## A.3 PUBLIC INPUT

## A.3.1 PUBLIC COMMENTS

Glendon Drive Streetscape EA  
Public TRACER

Glendon Drive Streetscape Environmental Assessment
Glendondrive.mindmixer.com
Public Information Centre No. 1
Thursday, November 26th, 2015 5:30pm-7:30pm
Komoka Library
COMMENT SHEET (Please Print Clearly)

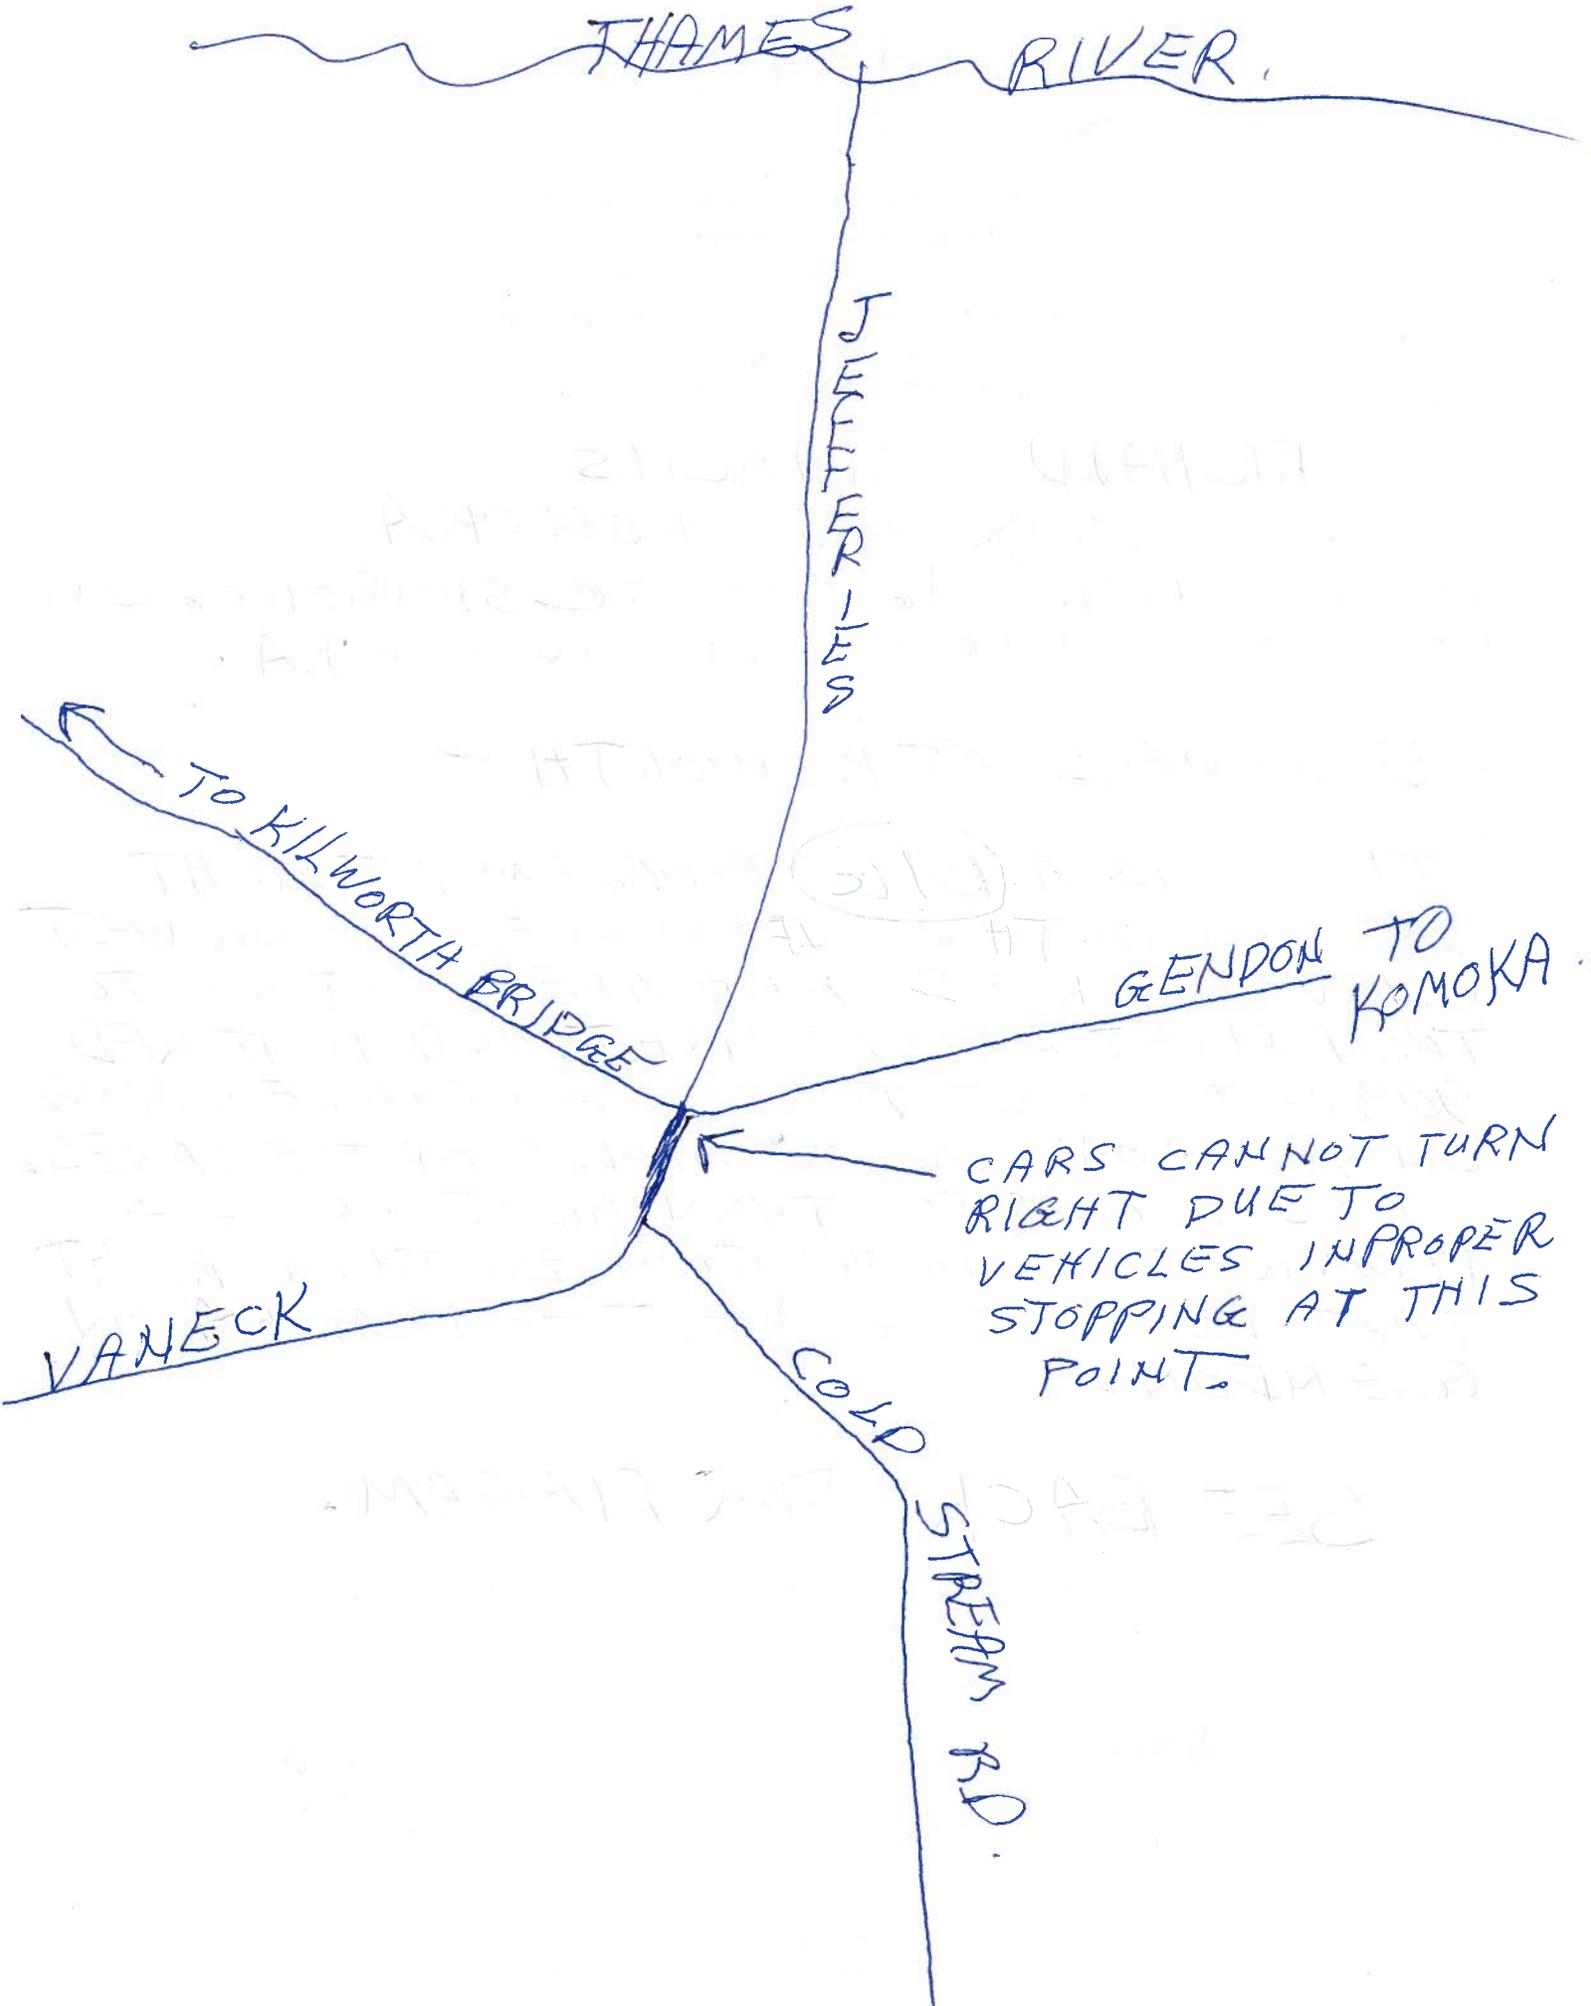
<b>Name:</b>	
<b>Mailing Address:</b>	
<b>Email Address:</b>	
<b>Interest (i.e. how you are affected):</b>	
<b>Comment:</b>	<p>- 5 CORNERS AT KILWORTH -</p> <p>THERE IS A <b>(BIG)</b> PROBLEM AT LIGHT AT KILWORTH. IF YOU ARE COMMING WEST ON VANECK RD AND ARE WANTING TO TURN RIGHT AT THE LIGHT, AND IF IT RED 90% OF THE TIME THERE IS A VEHICLE SITTING ON THE ROAD IN THE MIDDLE OF THE LANES. THIS BLOCKS THE TURN RIGHT VEHICLES FROM GETTING IN POSITION TO TURN RIGHT THAT WANT TO GO WEST TO KOMOKA ON GLENDON.</p> <p>SEE BACK FOR DIAGRAM.</p>

Figure 2

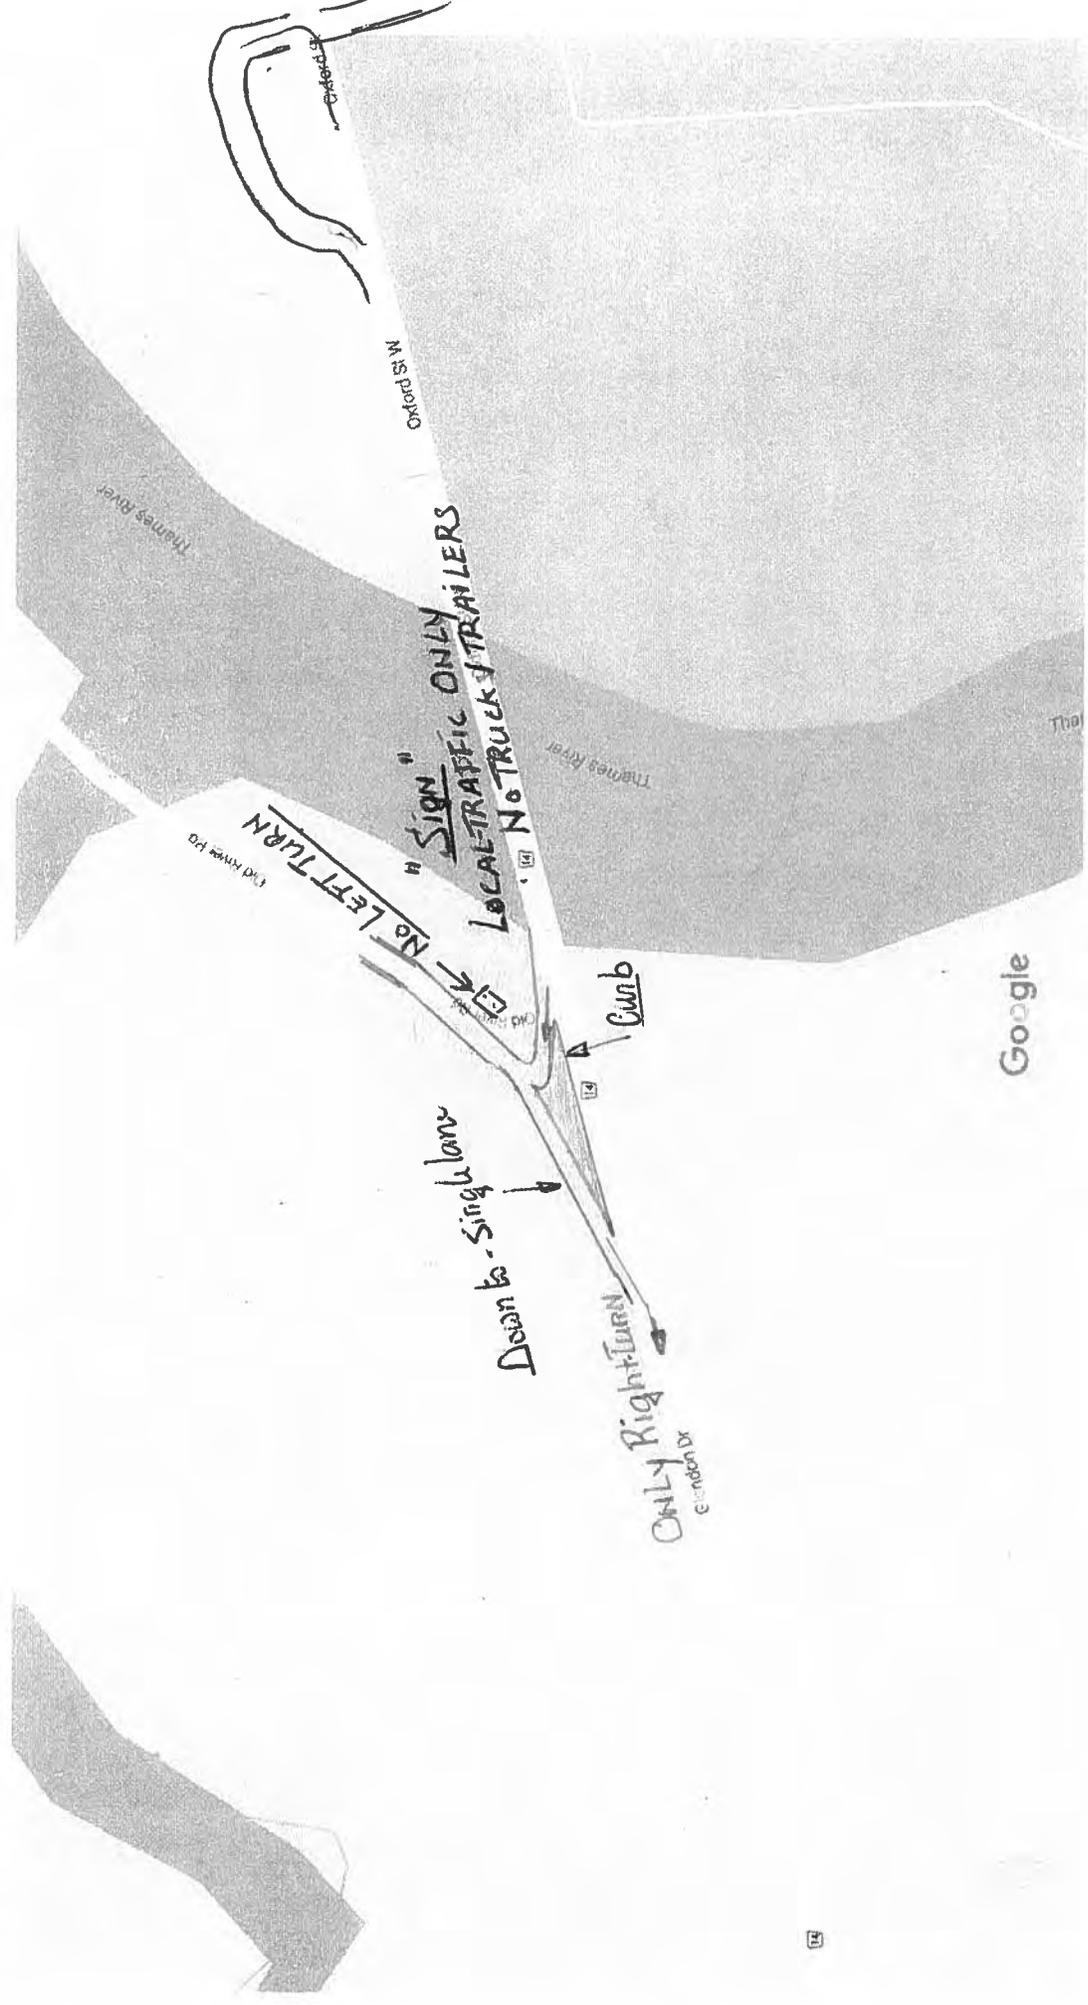
The EA study identified two traffic issues: turning movements at the intersection with Glendon Drive and the use of Old River Road as a short cut to avoid the intersection of Glendon Drive and Vanneck Road. At the second Public Information Centre (PIC), the EA Study team introduced a "recommended" solution for further review, involving a re-alignment of the intersection with Glendon Drive and the closure of a portion of Old River Road, resulting in two cul de sacs, approximately 650 metres and 1 000 metres in length. Figure 2 shows the display board from PIC2 which illustrates these proposals.

### **C. Concerns with the Proposed Roundabout at Glendon Drive and Jefferies Road**

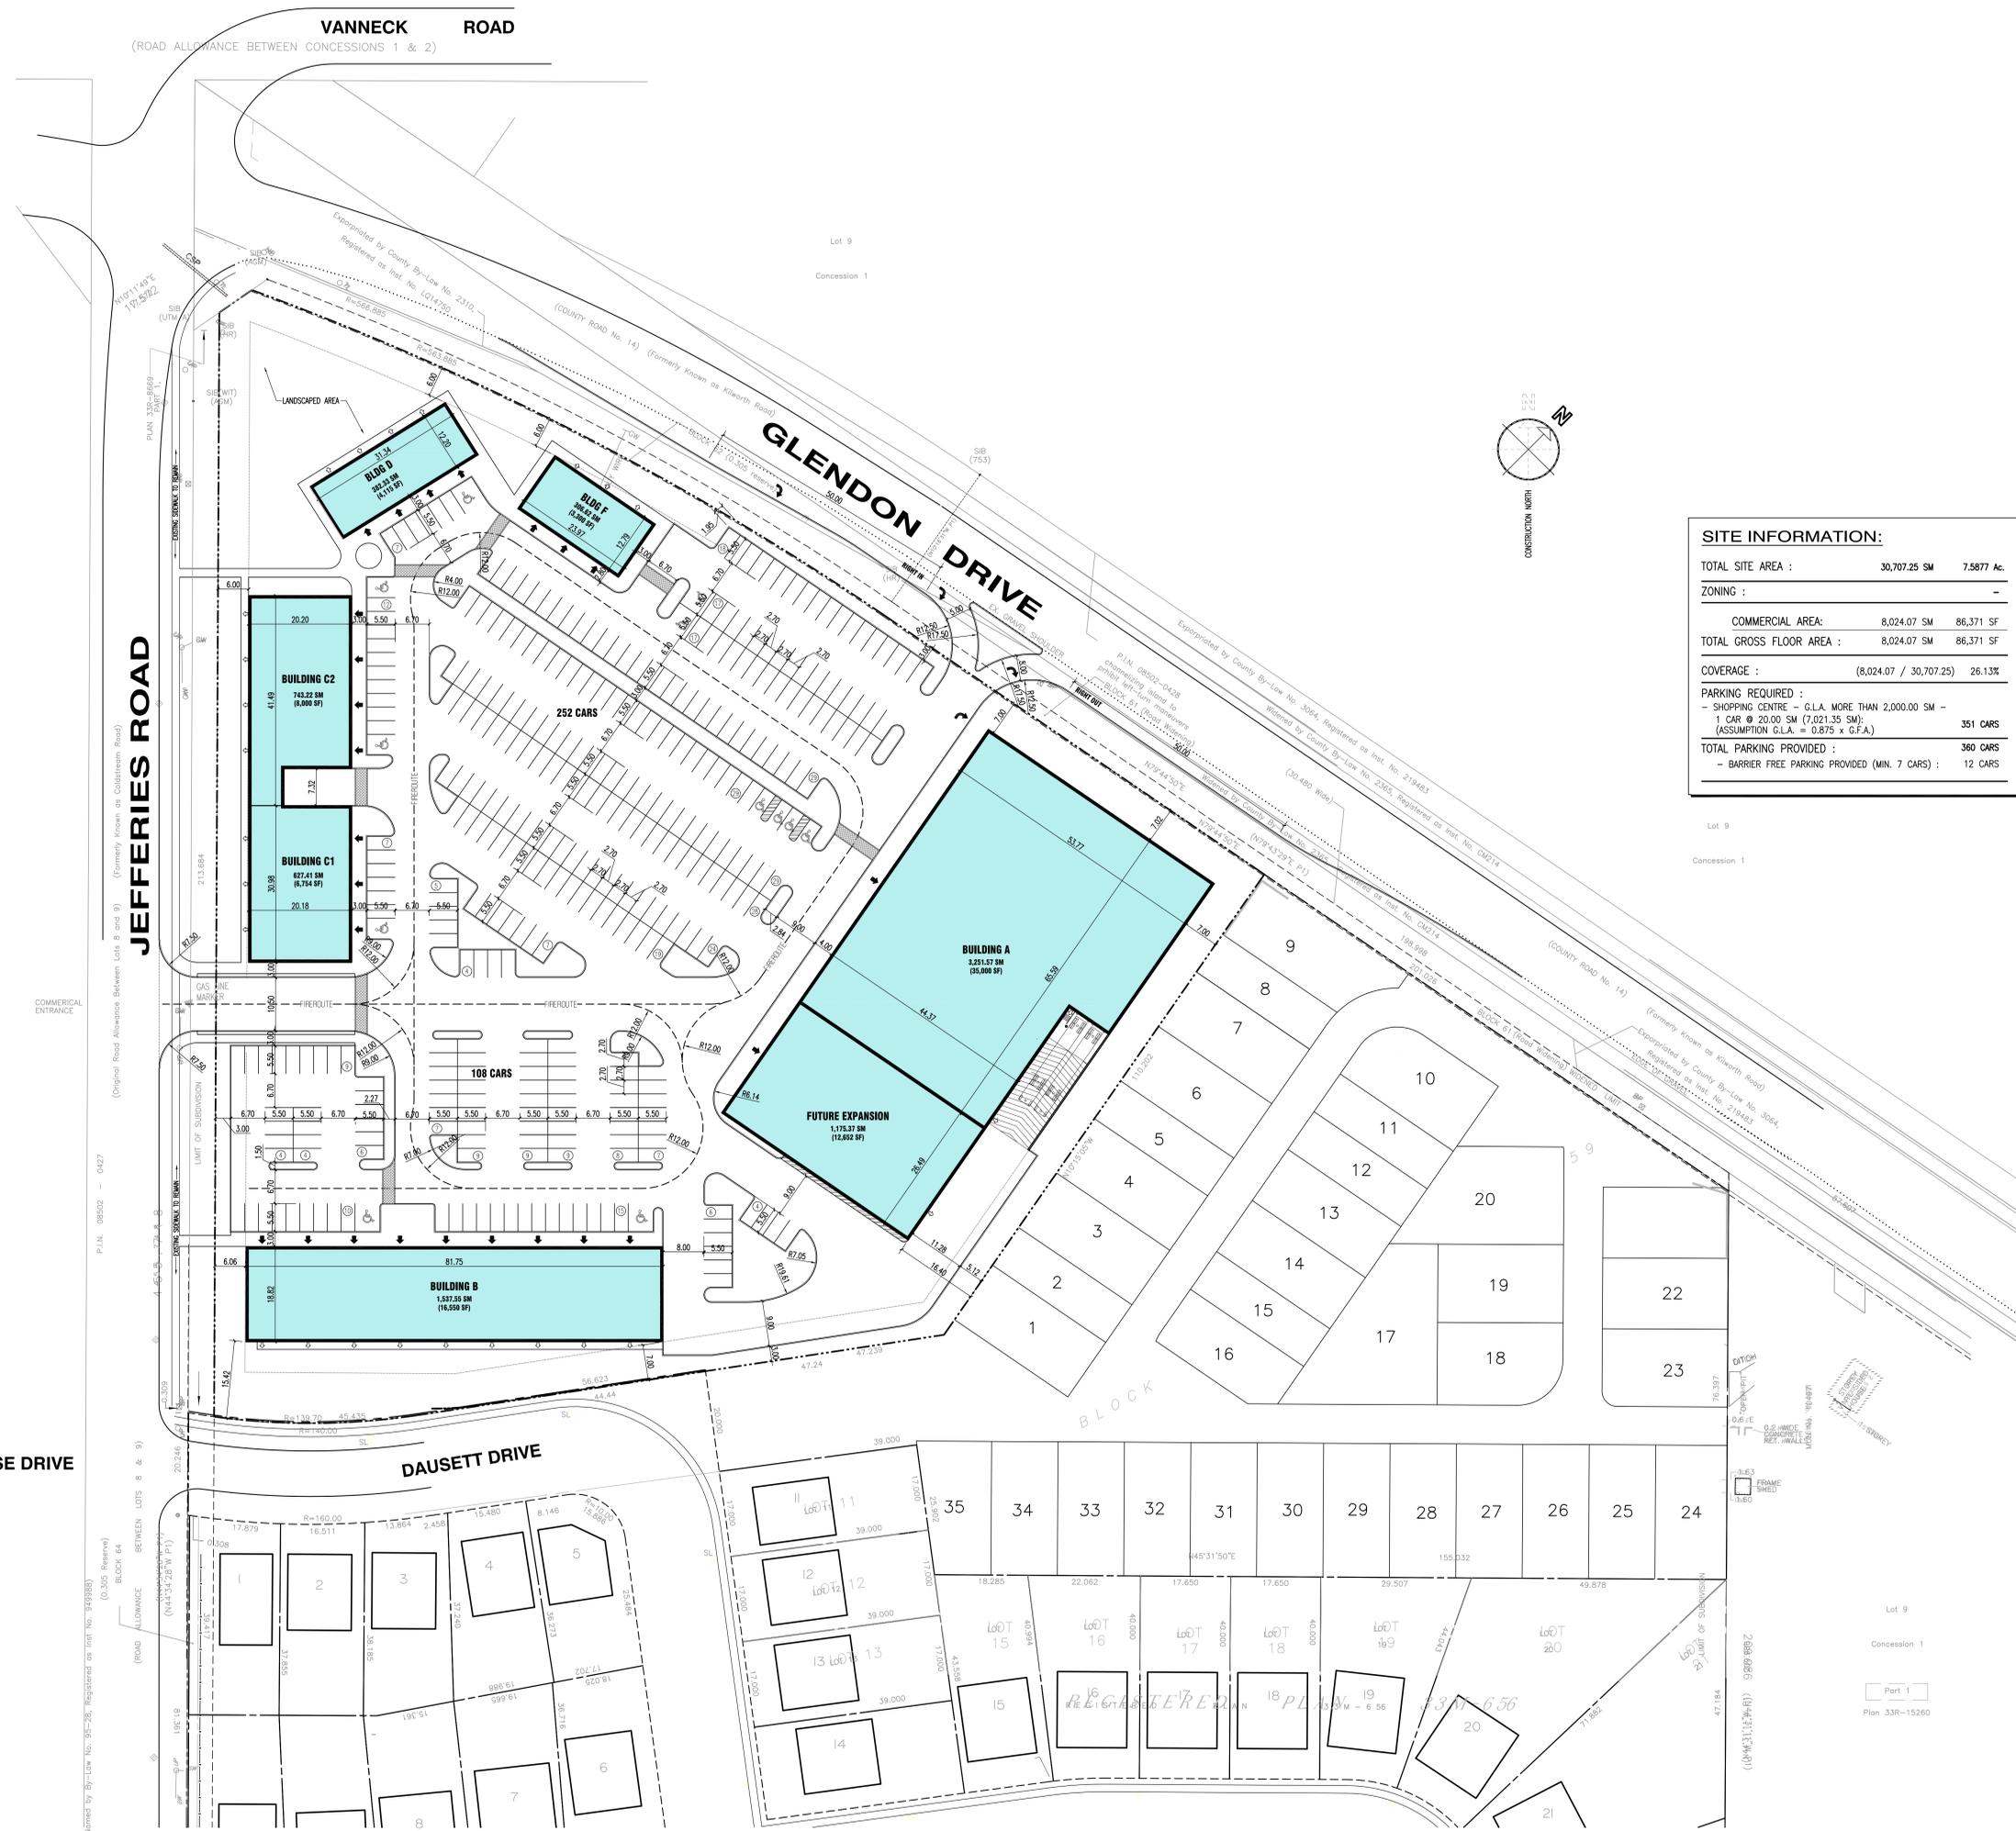
We are concerned that the recommended option for a roundabout at the intersection of Glendon Drive and Jefferies Road causes safety concerns in terms of road approaches and is not an appropriate recommendation for an intersection that is heavily used by regional truck traffic. Should this continue to be the recommended option, it would be critical to incorporate site generated traffic into the design of the roundabout.
